DESIGN <i>KE</i>	DRAWN BY <i>KE</i>	DART AEROSPACE LTD HAWKESBURY, ONTARIO, CANADA	
CHECKED <i>CP</i>	APPROVED <i>CP</i>	DRAWING NO. DSI 9174	REV. A SHEET 1 OF 1
DATE 99.11.16		TITLE UTILITY BASKET INSTALLATION	SCALE NTS
A	99.11.16	NEW ISSUE

DART SERVICE INSTRUCTION

AMEND PAGE 5 OF INSTALLATION DRAWING D206-540 REV G

CANADIAN STC: SH94-5
US FAA STC: SR00386NYREPLACE NUTS AND BOLTS WITH CASTLE
NUTS, PINS, AND BOLTS AS OUTLINED:

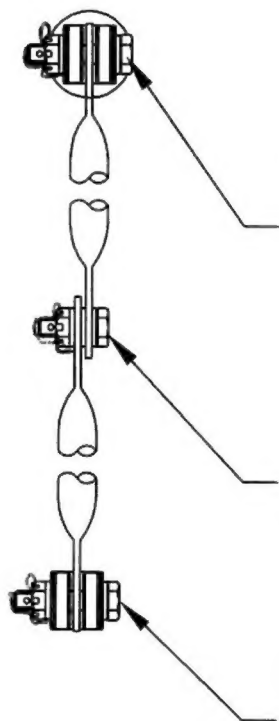
OLD HARDWARE

~~AN4-10A BOLT (1)~~
~~D2012-107 CLEVIS (1)~~
~~D2022-101 SPACER (2)~~
~~AN960JD416 WASHER (1)~~
~~MS21042L4 NUT (1)~~

~~AN4-5A BOLT (1)~~
~~AN960JD416 WASHER (3)~~
~~MS21042L4 NUT (1)~~

~~AN4-10A BOLT (1)~~
~~D2022-101 SPACER (2)~~
~~AN960JD416 WASHER (1)~~
~~MS21042L4 NUT (1)~~

NEW HARDWARE

AN4-12 BOLT (1)
D2012-107 CLEVIS (1)
D2022-101 SPACER (2)
AN960JD416 WASHER (2)
AN320-4 NUT (1)
AN380-2-2 PIN (1)

AN4-6 BOLT (1)
AN960JD416 WASHER (3)
AN320-4 NUT (1)
AN380-2-2 PIN (1)

AN4-12 BOLT (1)
D2022-101 SPACER (2)
AN960JD416 WASHER (2)
AN320-4 NUT (1)
AN380-2-2 PIN (1)
